W-6 UPPER SEGMENT: HWY 90 TO SW MILITARY DRIVE SEWER MAIN PROJECT

Solicitation Number: CO-00317

Job No.: 19-4519

ADDENDUM 1

DATE: MARCH 2020	SAWS PROJECT NO. 19-4519	SHEET NO. G6
DESIGN: JKN	KHA PROJECT NO.	
DRAWN: CRW	068665052	
CHECKED: JAF

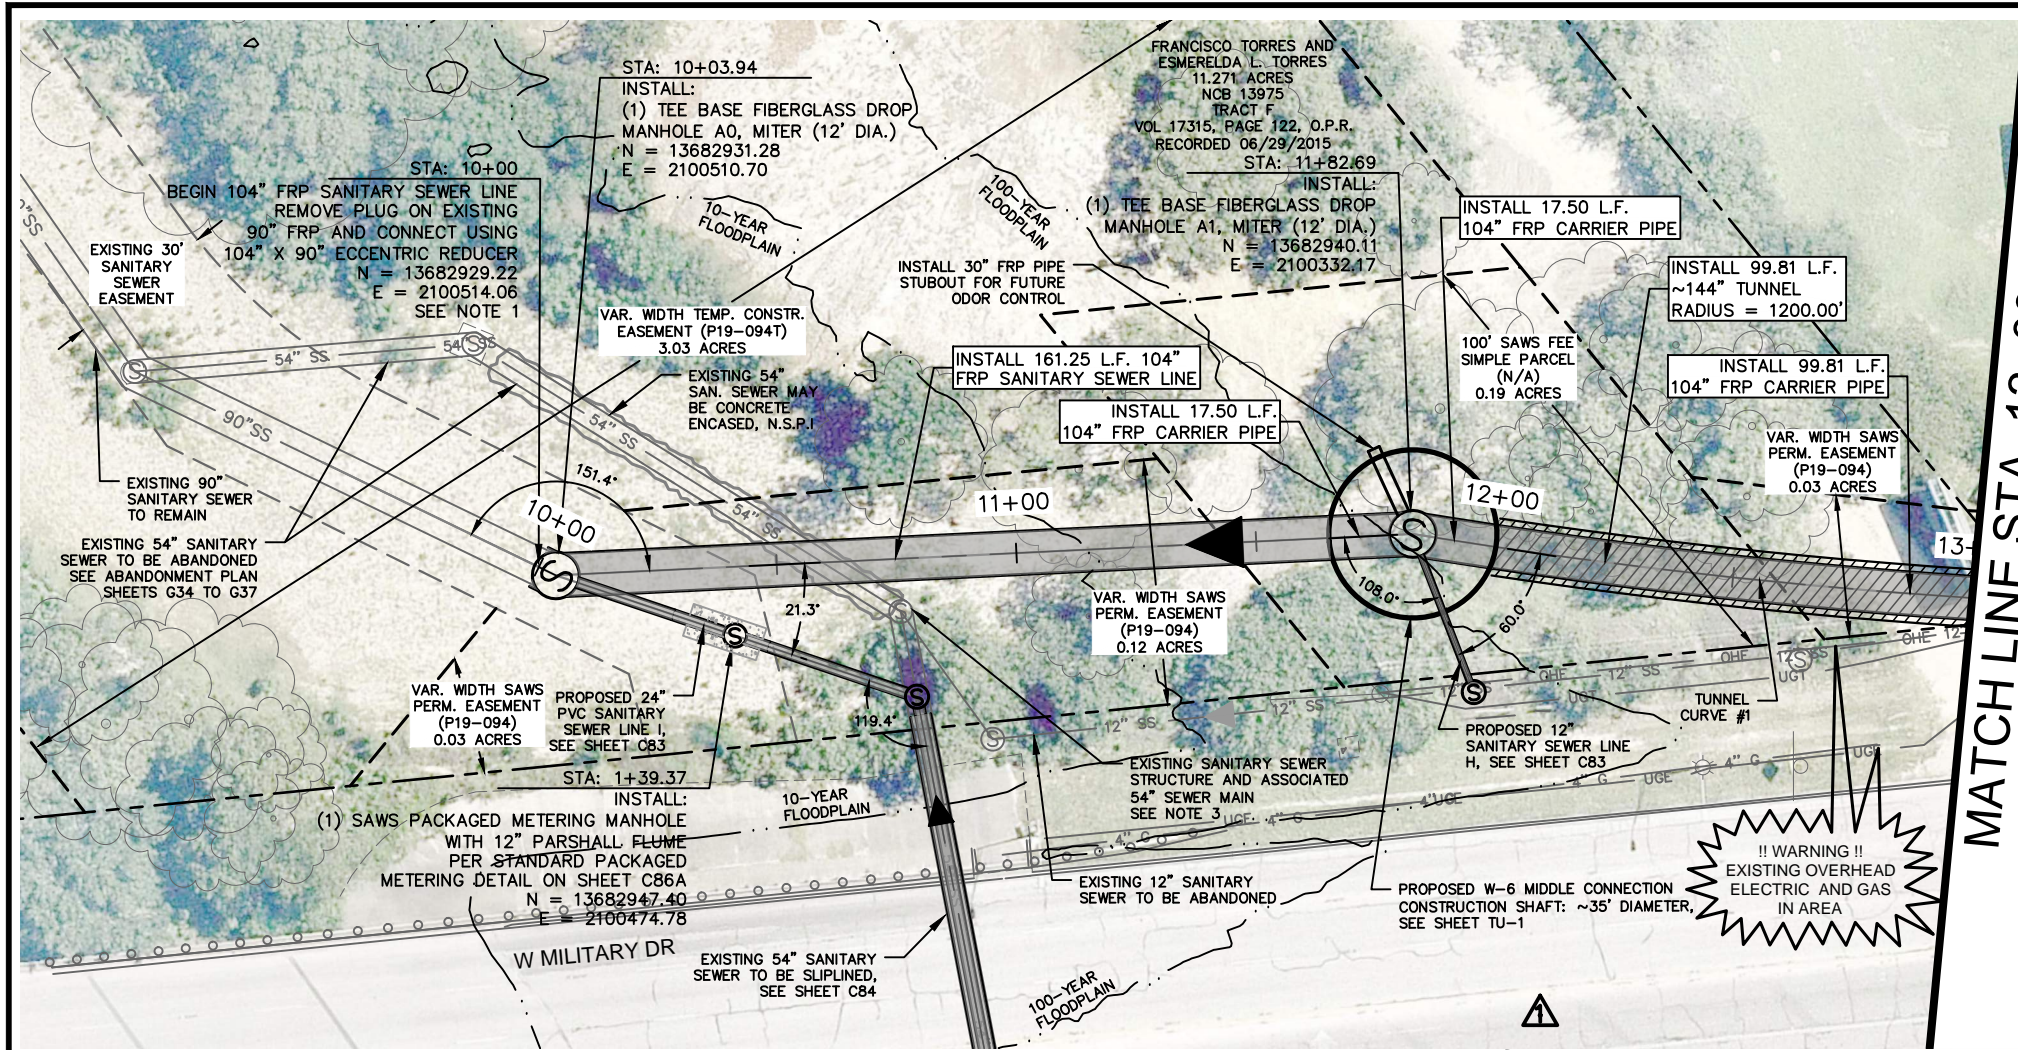
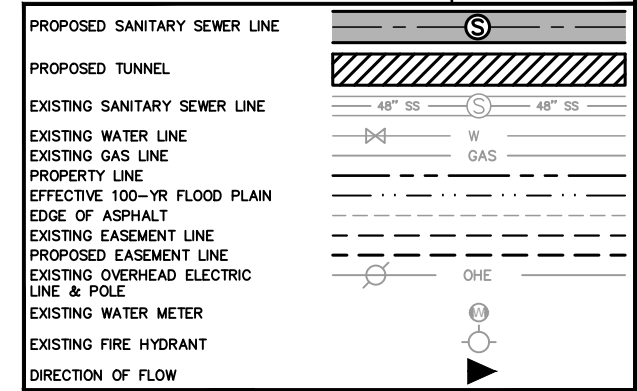
1. Remove the following plan sheets in their entirety and replace them with the attached, revised plan sheets. (Revisions made from the original sheets are depicted by revision clouds around the changed portions.)
- Sheet G6 - OVERALL QUANTITIES - Revise and replace sheet in its entirety.
 - Quantity for line item 57 - 853A Extra Depth (>6' Tee Base Fiberglass Manhole, Miter (12' Diameter) "46" with the following: "47"
 - Item no. 60 through 65
 - 60 - "857A" with the following: "857"
 - 61 - "857A" with the following: "857"
 - 63 - "857A" with the following: "857"
 - 64 - "857A" with the following: "857"
 - 65 - "857A" with the following: "857"
 - Item no. 117 "100.1 Mobilization (Max 2% of Items 1 to 106)" with the following: "100 Mobilization (Max 2% of items 1 to 106)"

- Item no. 118 “101 Mobilization (Max 1% of Items 1 to 106)” with the following: “100 Mobilization (Max 1% of Items 1 to 106)”
- Sheet C1 - 104-INCH SANITARY SEWER PLAN & PROFILE- Revise and replace sheet in its entirety.

DATE: MARCH 2020	SAWS PROJECT NO. 19-4519	SHEET NO. C7
DESIGN: JKN	KHA PROJECT NO. 068665052	
DRAWN: CRW		
CHECKED: JAF

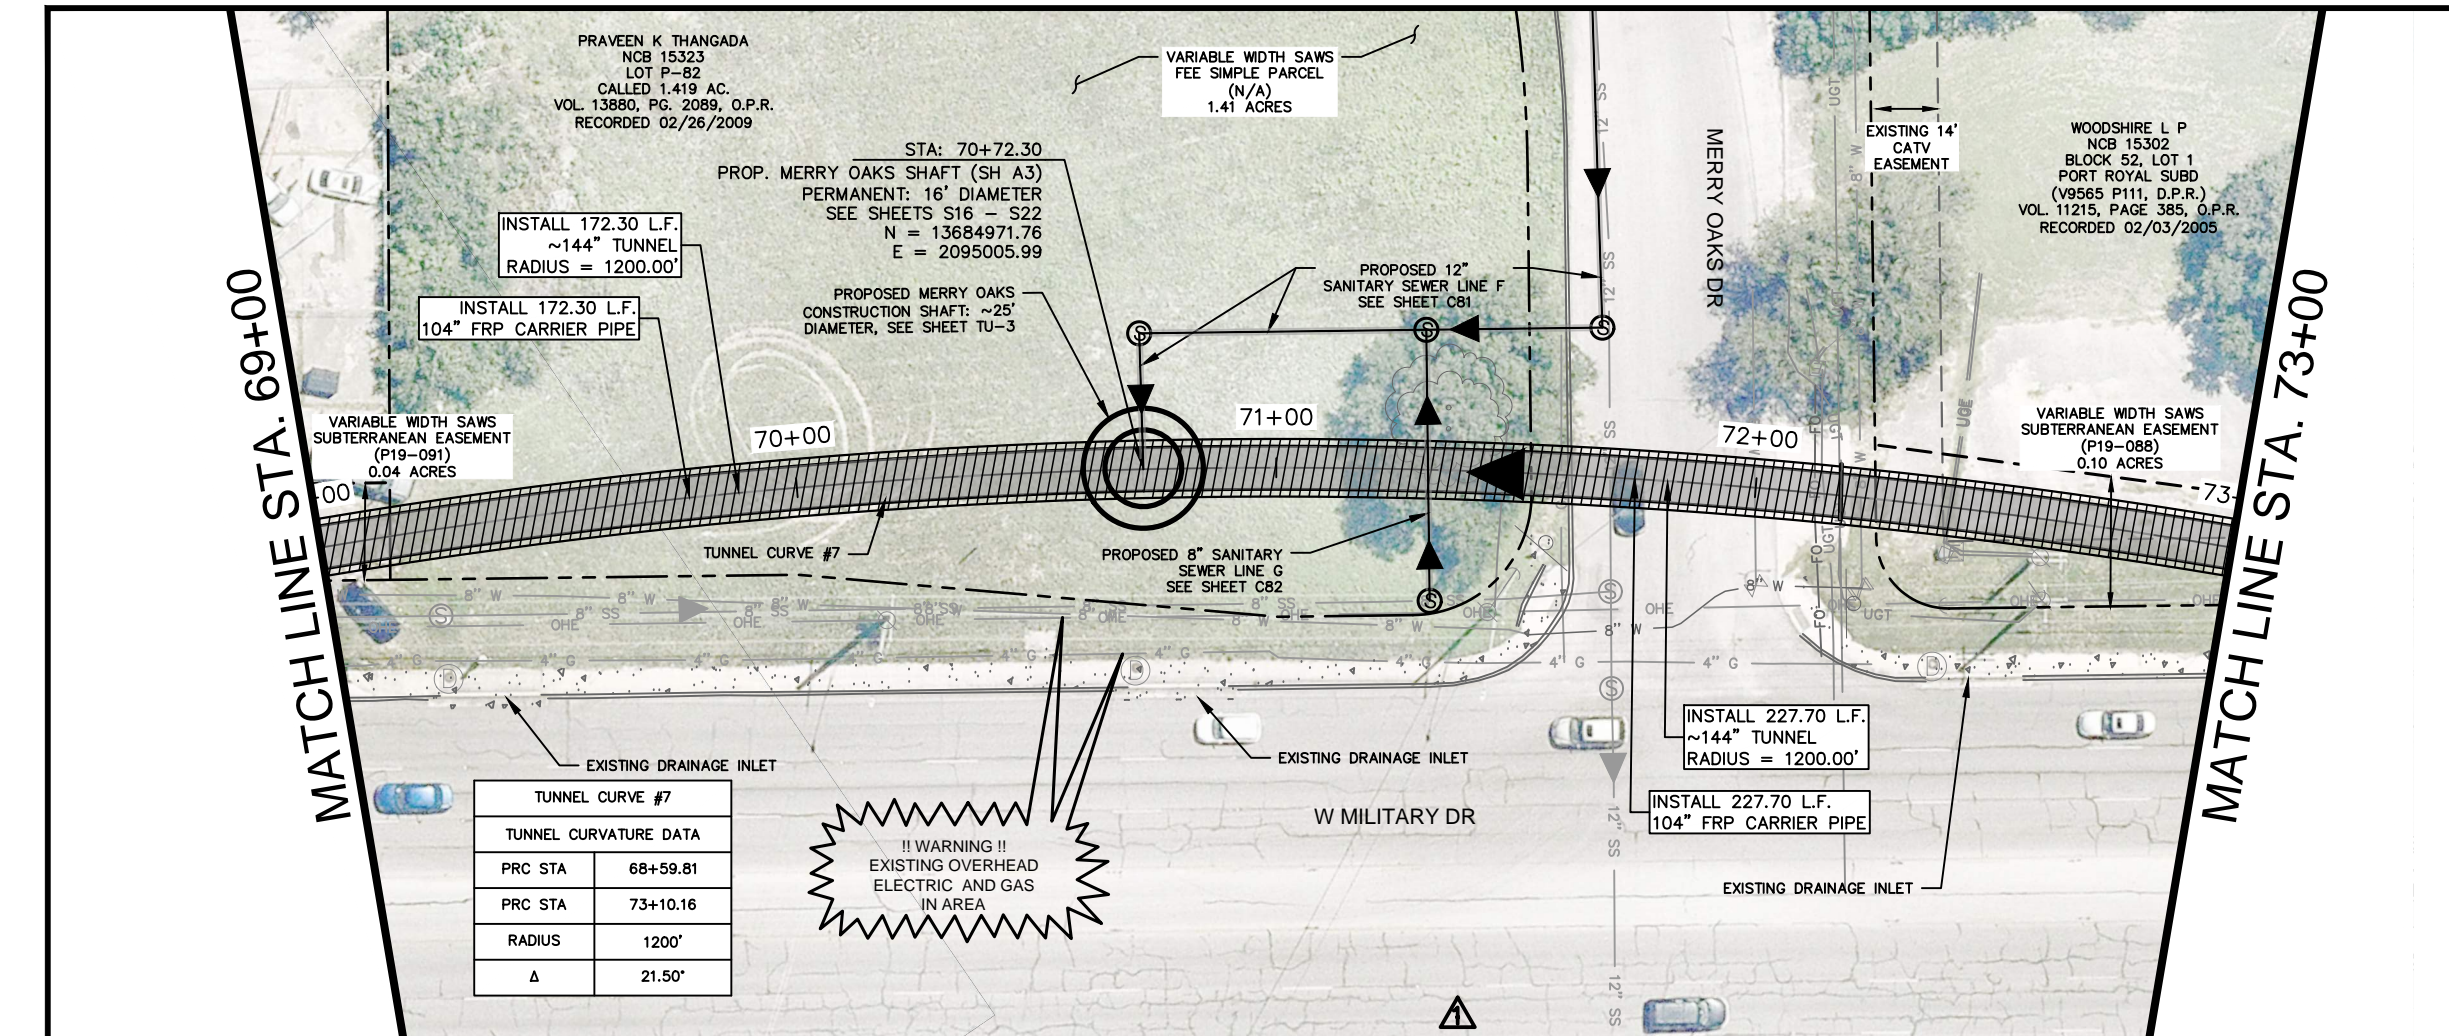
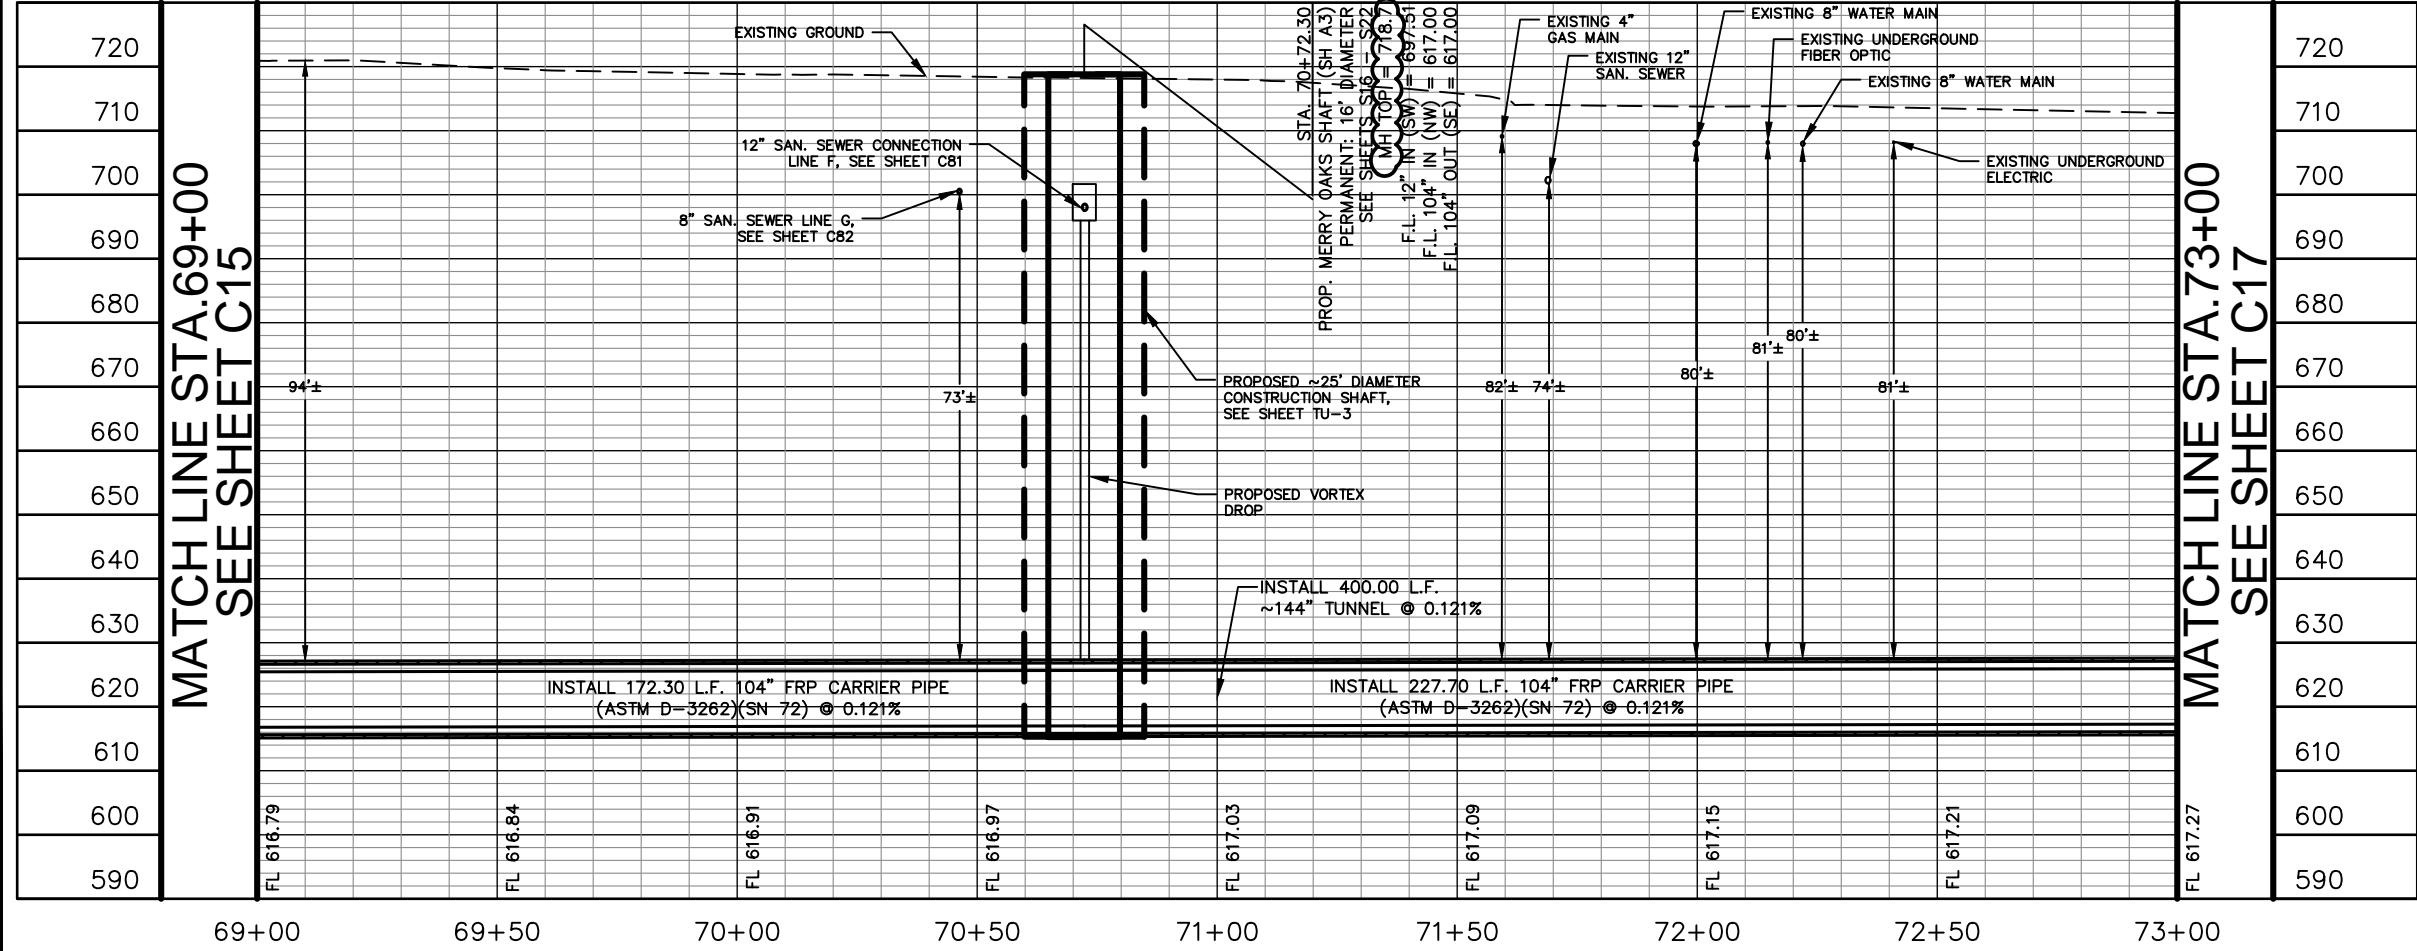
- Quantity for line item 857A 104-inch FRP (ASTM D-3262) (SN 72) Sanitary Sewer Line (30’-35’ Depth) “857A” with the following: “857”.
- Sheet C7 - 104-INCH SANITARY SEWER PLAN & PROFILE – Revise and replace sheet in its entirety.

- Label of shaft top rim elevation for Prop. Pearsall Shaft (SH A2) - “SHAFT TOP = 717.6” with the following: “SHAFT TOP = 717.8”.
- Sheet C16 - 104-INCH SANITARY SEWER PLAN & PROFILE – Revise and replace sheet in its entirety.

DATE: MARCH 2020	SAWS PROJECT NO. 19-4519	SHEET NO. C49
DESIGN: JKN	KHA PROJECT NO. 068665052	
DRAWN: CRW		
CHECKED: JAF

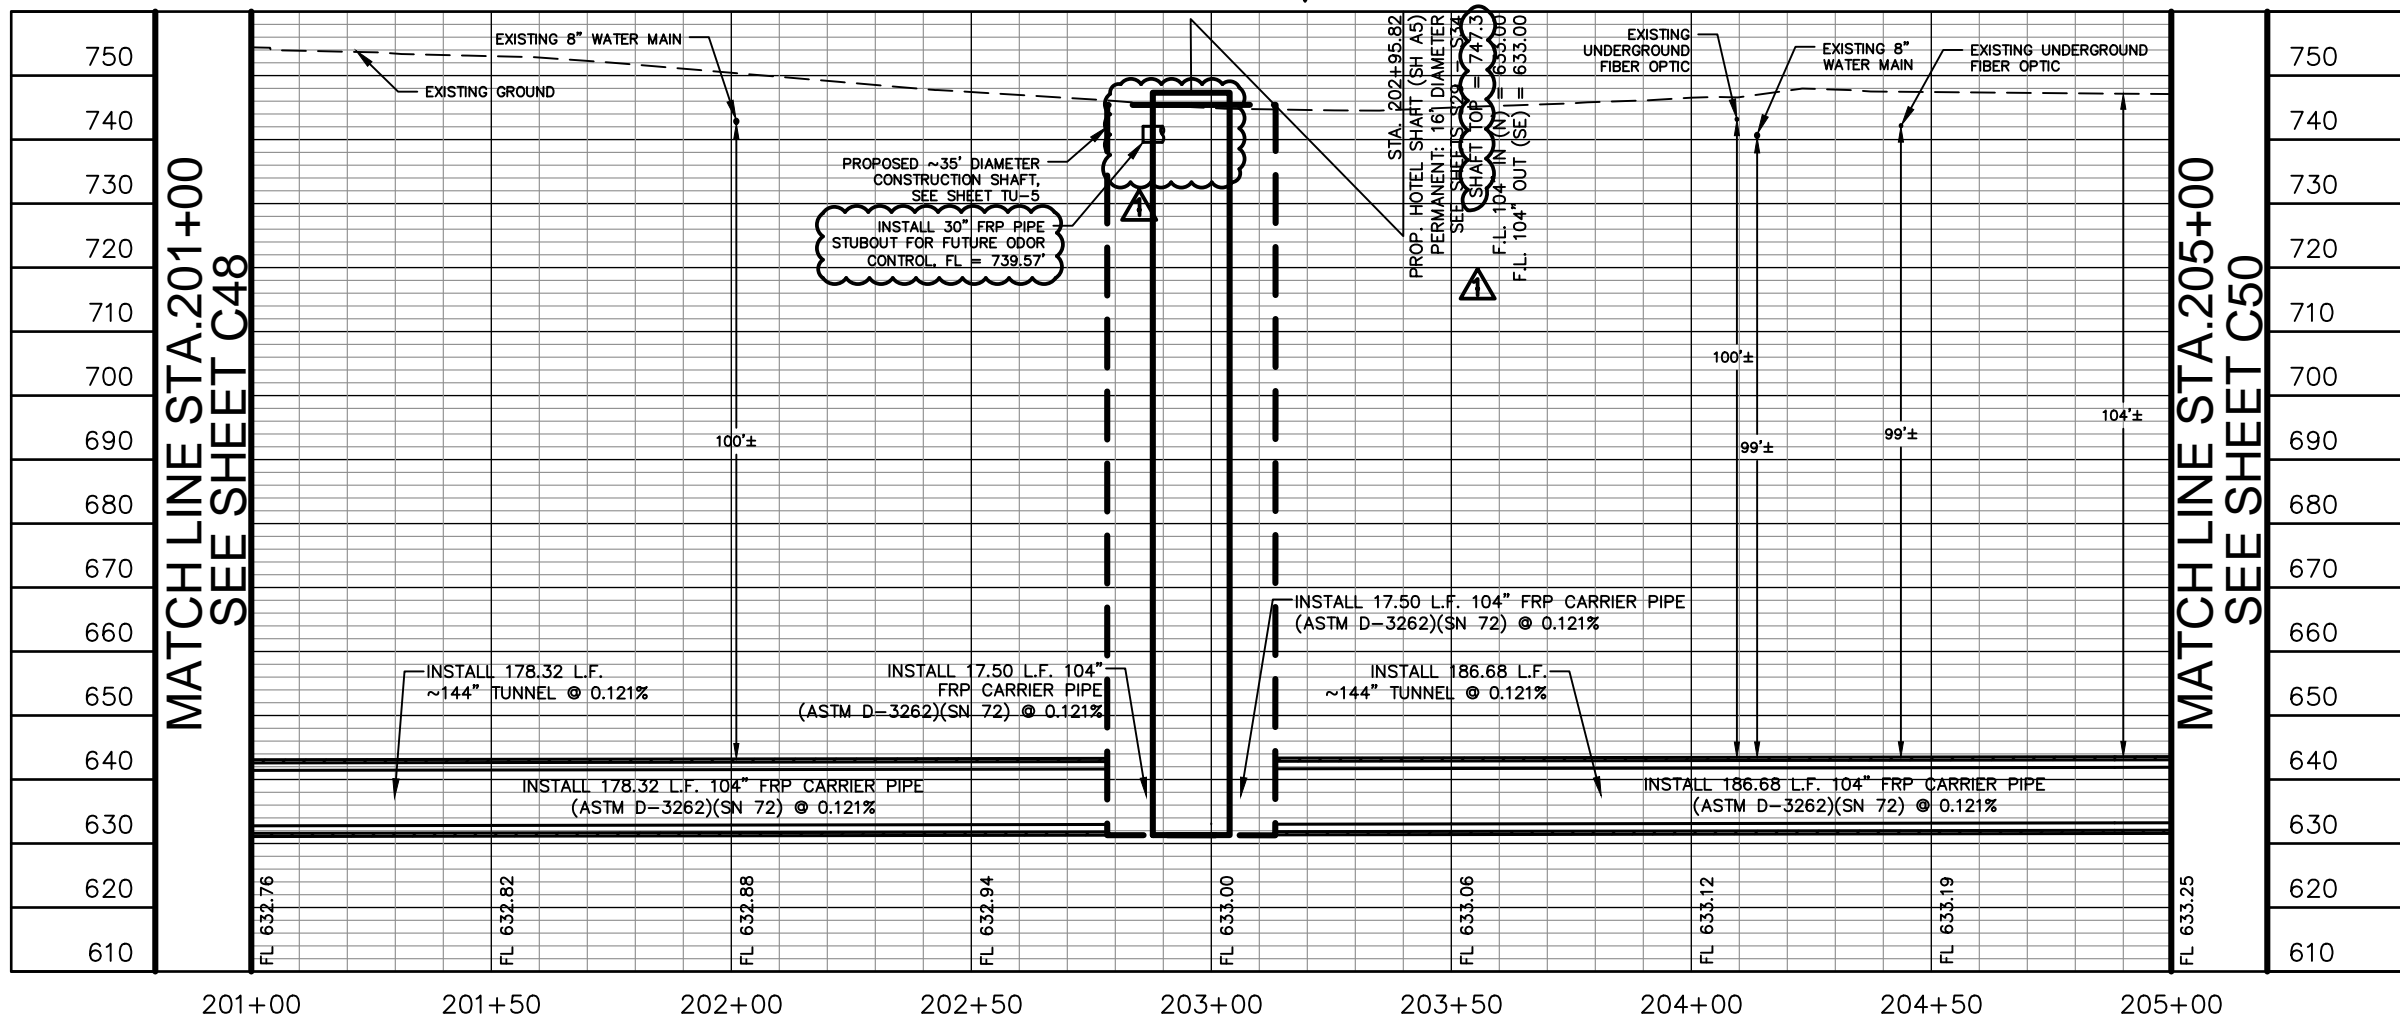
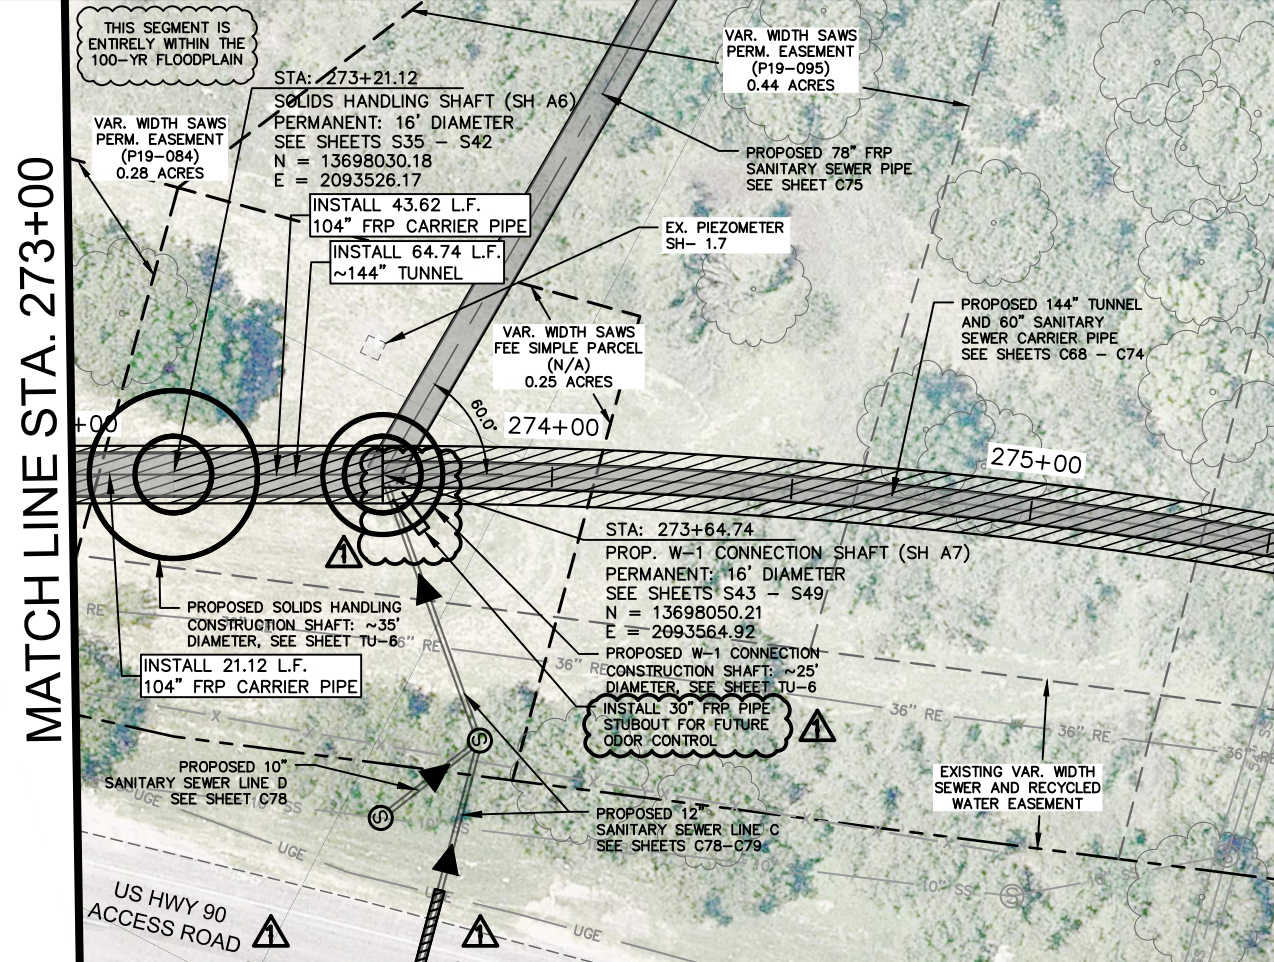
- Label of shaft top rim elevation for Prop. Merry Oaks Shaft (SH A3) - “SHAFT TOP = 718.2” with the following: “SHAFT TOP = 718.7”.
- Sheet C49 - 104-INCH SANITARY SEWER PLAN & PROFILE – Revise and replace sheet in its entirety.
